## Building Permit Review Comments Response Letter:

Re: **Staff Report DSRFY2023 - 0006**  
**Starbucks**  
**5586 N Maple Grove Rd. Garden City, Idaho 83714**

Below is a list of responses to review comments for Starbucks Garden City, each followed by relevant details and actions taken.

L-1.0

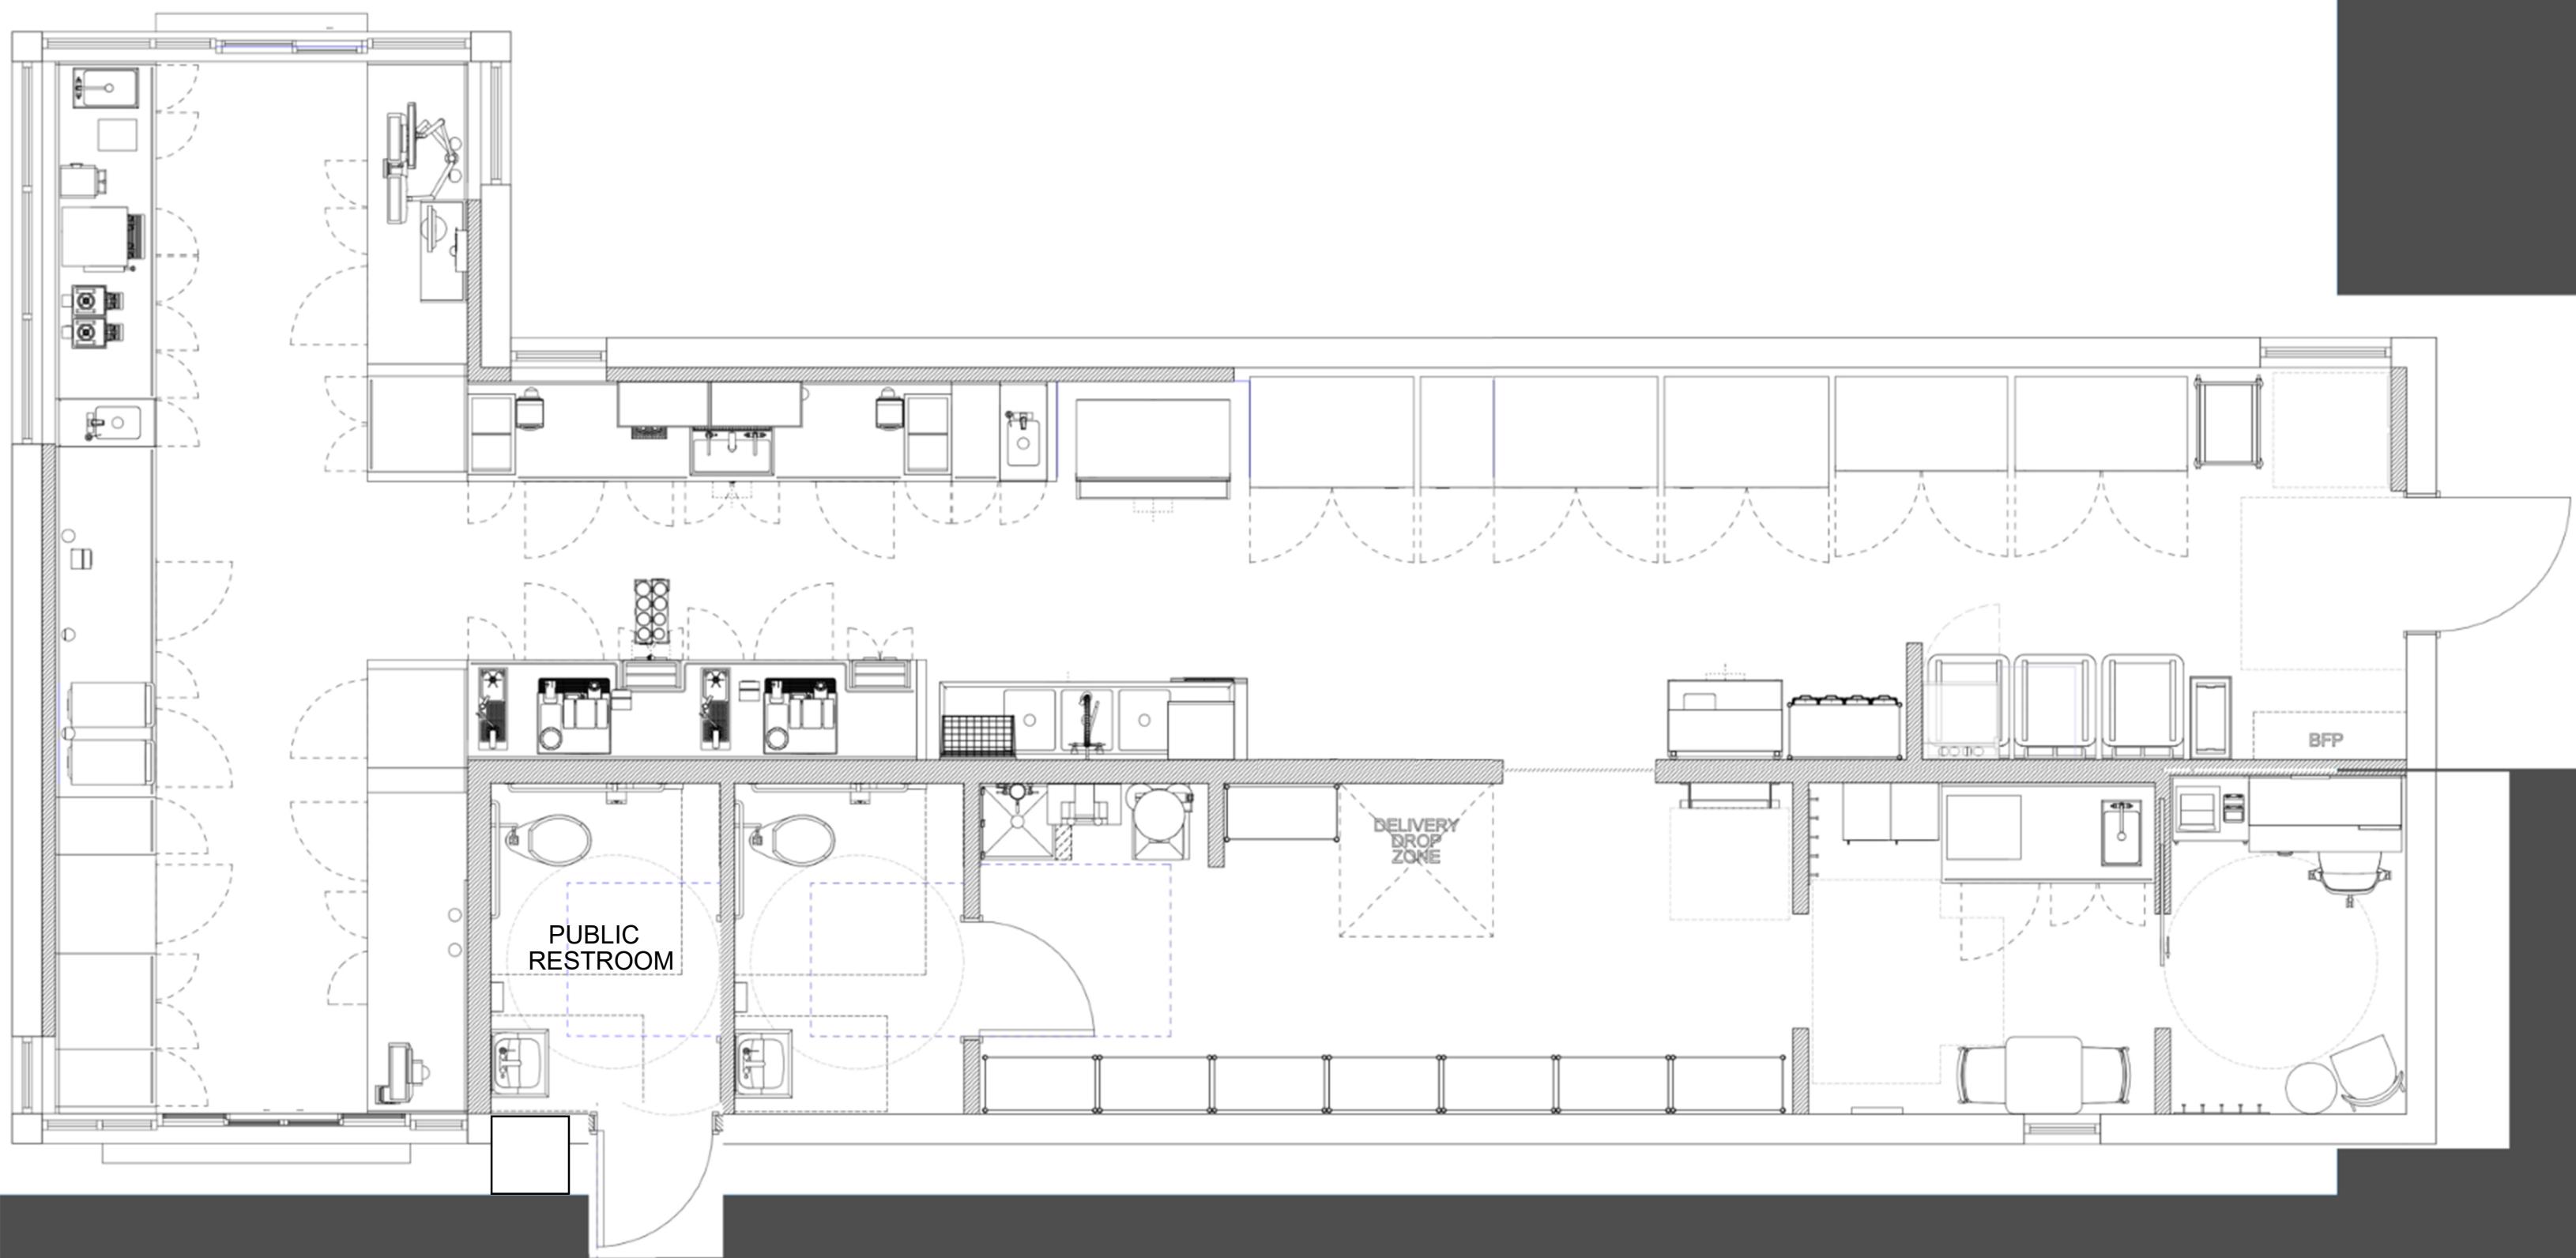
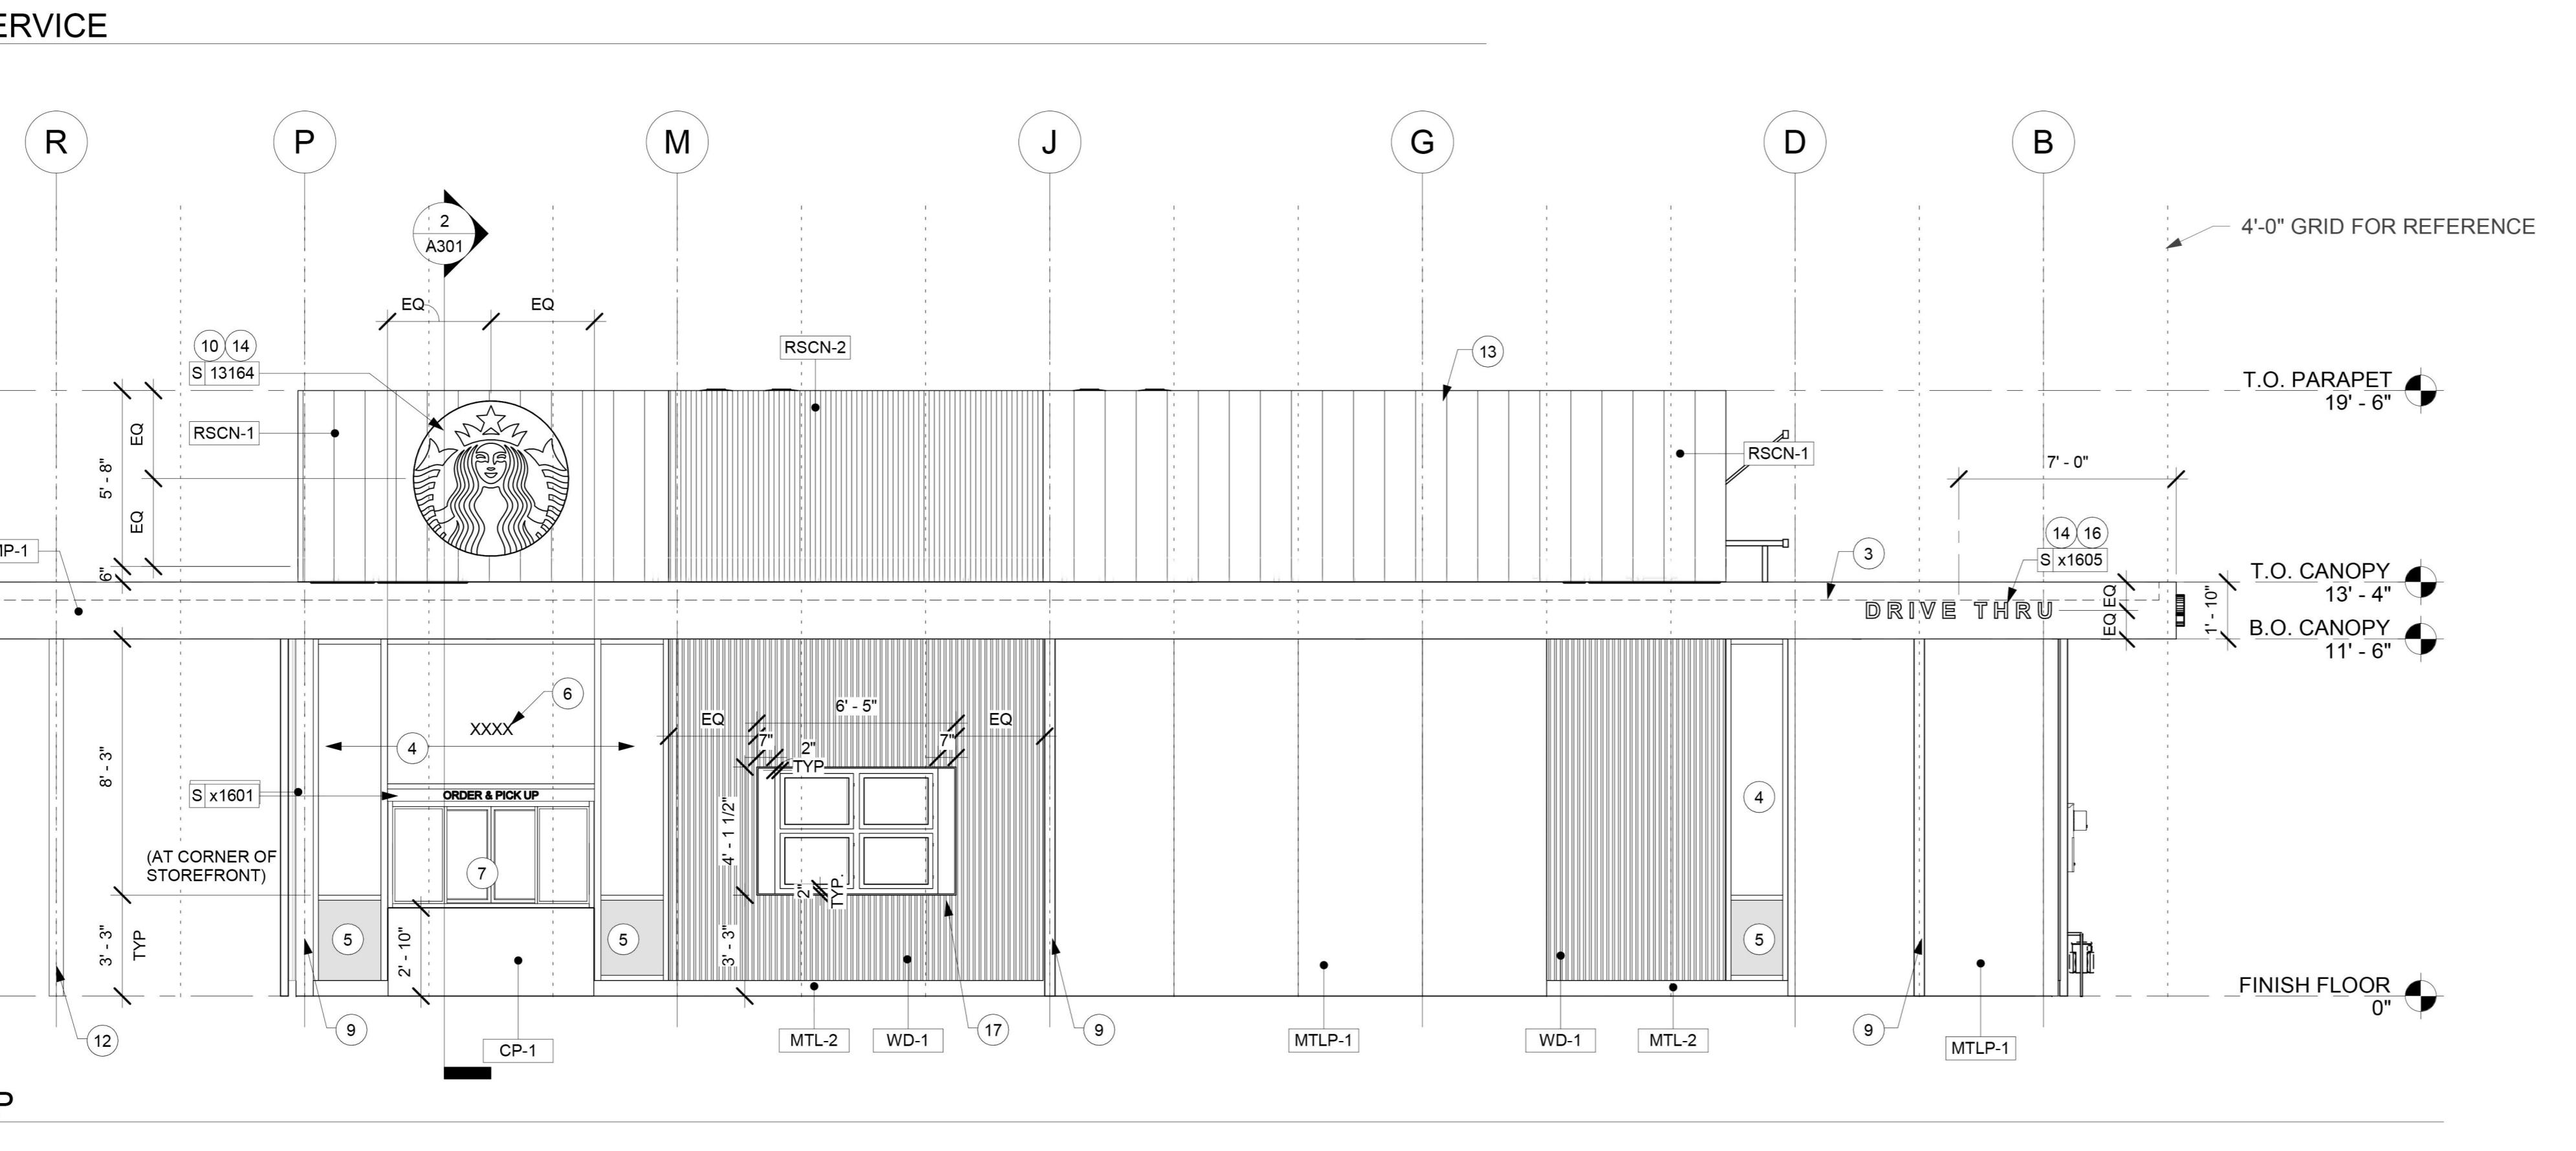
1. **District Attorney** - The district does not approve of trees within the district's easement.  
*R1. Trees have been removed from the utility easement, see updates to sheet L-1.0.*

1. **8-4I-4** - Landscape plans do not appear to show 70% vegetation in any of the landscaped areas except for the perimeter landscaping areas.

2. **8-4I-4** - Site plans state that 28% of the site is dedicated for landscaping. There is not enough information to differentiate the overall calculations from that of which meets this requirement, assuming the setback and perimeter landscaping provided was included in the overall calculation. Additional information is required for review. 70% of landscaped areas are required to be of vegetative material at maturity.

*R1. Please see General Note G on sheet L-1.0.*

*R2. Please see General Note G on sheet L-1.0.*
